RE – Yass Valley Wind Farm Preferred Project Report response (our ref. 4743)

ISSUES AND APPROACH OVERVIEW

1 CLARIFICATION OF ISSUES / DISCREPANCIES RAISED IN OEH SUBMISSION

TITLE
 EA & PPR
 Turbine Layout
 Comparison

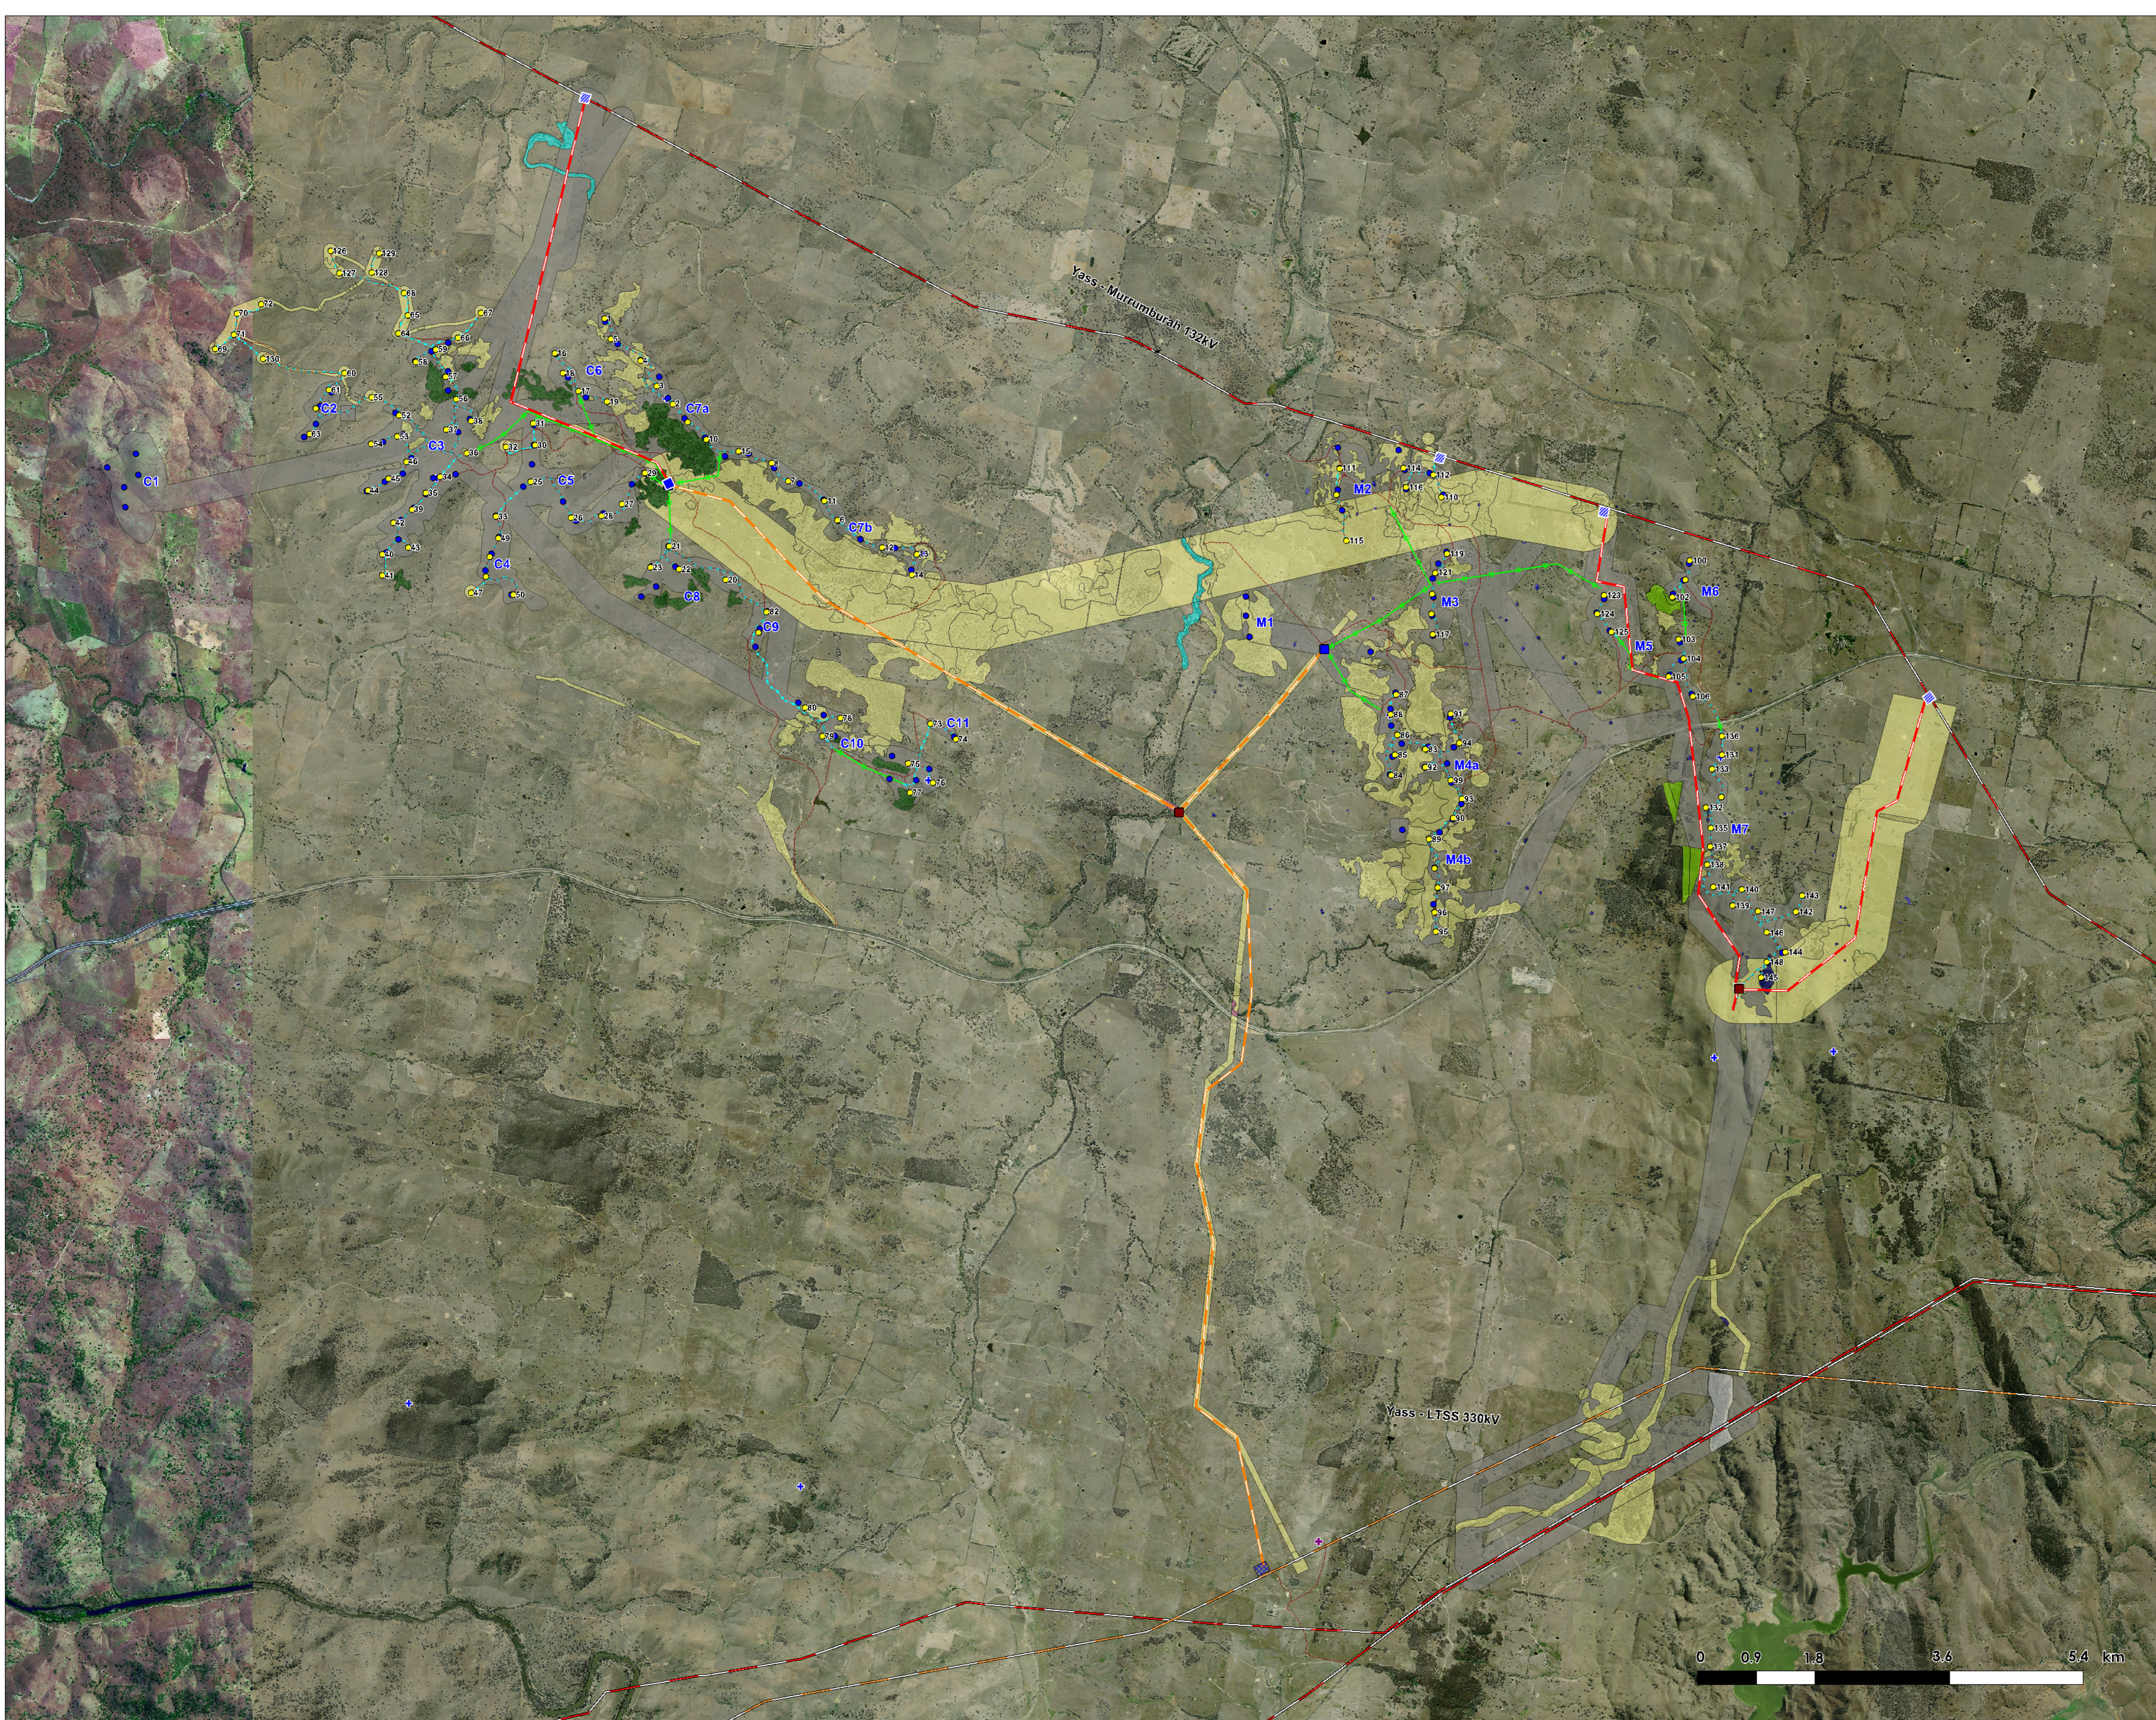
Turbine locations:	<p>OEH have nominated a number of turbines they do not support, close to woody vegetation and ridges.</p> <p>It is noted that while all high constraints areas mapped by ngenvironmental have been avoided by turbines, some associated infrastructure falls within these areas (tracks and powerlines). It is proposed that these areas be shown on the constraints mapping such that minimal road widths only are allowed in these areas.</p> <p>It is noted that OEH have stipulated several turbines they do not support that are located outside of constraints areas. These turbines cannot be moved further from the mapped constraints. It is proposed that OEH's input into the constraints mapping will ensure a clear map set accompanies the development proposal. After consideration of the additional information provided in this letter and gleaned from the site inspection, we invite OEH to identify additional high constraints areas to be included in this map layer. If any further site inspections are required by OEH, Epuron will facilitate this.</p>	<p>Pre approval</p> <p>A constraints layer will be developed with input from OEH to ensure all areas not endorsed by OEH are included.</p> <p>If this requires any additional site inspections by OEH, Epuron would facilitate this.</p>

1. Layout comparison EA vs PPR layout, showing changes in turbine layout since the publically exhibited EA.
2. Vegetation types Updated vegetation mapping to show ‘worst case’ clearing estimate of EEC vegetation:
 - Areas of ‘pasture’ and ‘exotic’ vegetation have been moved in to Box Gum Woodland in poor-moderate condition, as a precautionary treatment, in advance of detailed field validation.
 - EEC in ‘moderate to good biometric condition’ has been outlined.

TITLE
 Project Infrastructure &
 Vegetation
 Complete site

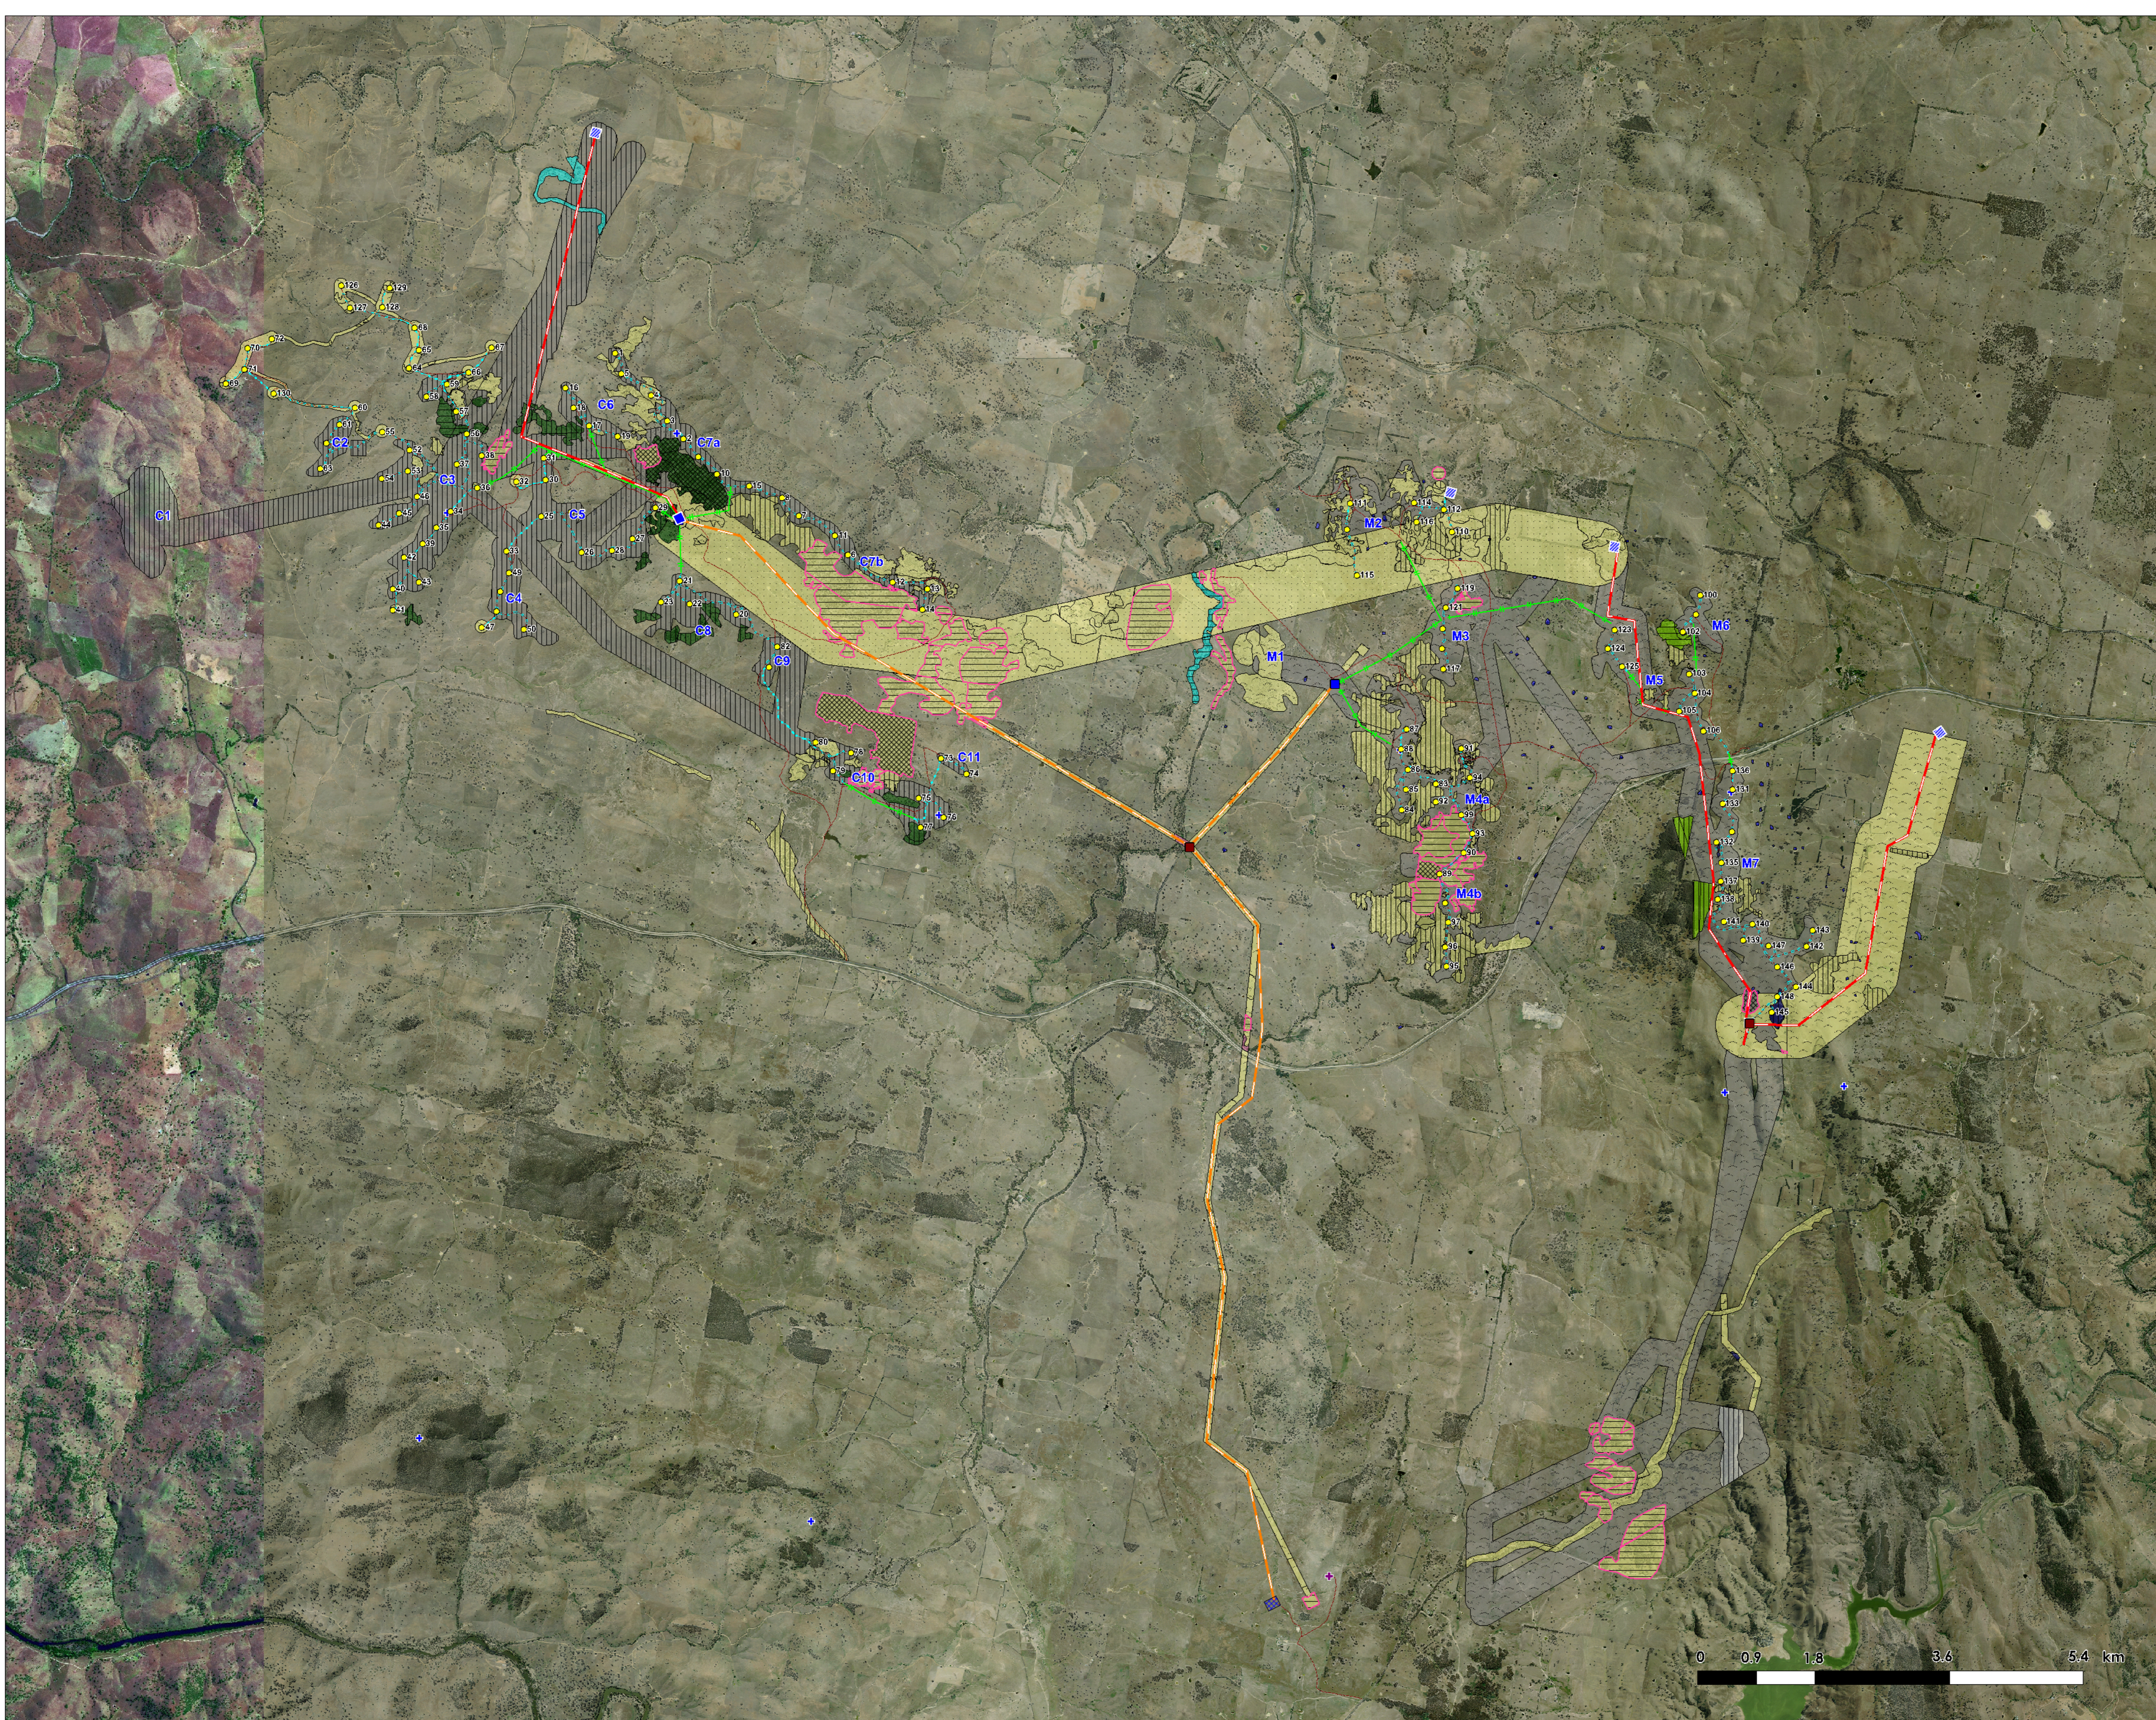
Calculation of impacts: Definitions, impact areas, significance of impact.	<p>There has been some difficulty surrounding the definition of box gum woodland and derived pastures.</p> <p>The field assessments for the original BAs (Marilba, Coppabella) were undertaken in 2007-2009 with the reports finalised in mid 2009. The SER was compiled at the end of 2012. The benchmark for biodiversity assessment has been moving during this time. The Biobanking scheme and associated biometric condition classes commenced in 2008, with its two category condition classification, lower benchmark for overstorey cover and minimum remnant unit of 0.25ha. This is particularly relevant to mapping and classifying secondary pasture that has a high percentage of exotic species.</p> <p>We used a 5-class condition categorisation for all three assessments to assist the assessment of impact (presented below, two left columns). When compared to the biometric condition classes, it can be seen that relative degraded secondary pasture can still qualify as moderate to good condition vegetation. While exotic dominated areas have been mapped as 'exotic' or 'pasture' in previous assessments, it is recognised that it should have been ascribed to a vegetation types (particularly relevant where vegetation could be derived from Box Gum Woodland).</p> <p>Regarding the difficulties in mapping vegetation type and condition, the Coppabella BA states:</p>	<p>Pre-approval</p> <p>Vegetation types and condition have now been updated to reclassify 'exotic' and 'pasture' as Box Gum Woodland in 'poor - moderate condition'.</p> <p>The revised mapping allows an upper limit / worst case EEC impact area estimate.</p> <p>These two outputs ensure an agreed figure for EEC impact is determined prior to works.</p> <p>Post approval</p> <p>The BMP would include protocols to manage vegetation clearing. This plan would be prepared in consultation with OEH. It is suggested that the plan include the following:</p> <p><i>All areas of clearing to be field validated prior to clearing (vegetation type, condition, area) in appropriate seasonal conditions (likely to be late Spring – early Summer, dependant on conditions).</i></p>

OEH issue	Comment / clarification	Suggested timing and approach
	<p><i>The vegetation communities present on the site intergrade and overlap, making vegetation mapping problematic. The spatial extent of the different vegetation communities in the region and their condition are related to cover and diversity of native groundcover species. Groundcover composition and condition may be highly variable over a small area, and will often change over time depending on season, water availability and grazing pressure. These factors, combined with the high level of disturbance to the understorey from grazing makes definition and mapping of vegetation types and their condition in the field or using aerial photographs problematic.</i></p> <p>While it is difficult to say with certainty which vegetation type a degraded pasture is derived from, for the Yass site the majority of the site would have been Box Gum Woodland and therefore a precautionary approach would reclassify areas of pasture to this vegetation type. As such, areas mapped as 'exotic' and 'pasture' have now been moved into Box Gum Woodland category. Condition has been designated as 'poor - moderate', as some of these areas are native dominated.</p> <p>Site inspection on 20th November 2013 verified that some of these areas would more accurately be mapped as entirely exotic (cropped paddocks) or ascribed to other vegetation types (Long-leafed Box / Red Stringybark Dry Grass Forest on ridges near turbines C2, 9 and 10). However, without further field validation, the mapping and calculation and impact areas based on the mapping are now highly conservative and overestimate the amount of clearing in Box Gum Woodland.</p>	<p>This would ensure that clearing does not exceed the approved amount of clearing and would make clear the offset requirement.</p>

It is noted that the additional areas of vegetation now reassigned as ‘moderate to good’ biometric condition are comprised of the lower condition areas, considered to be highly degraded and therefore not originally mapped as EEC. These are areas of low tree density and large proportion of exotic understorey, as verified with OEH on the site inspection (November 20, 2013). In the absence of ground truthing, we have included these as ‘moderate to good’ biometric condition to demonstrate offsets are achievable for this area.
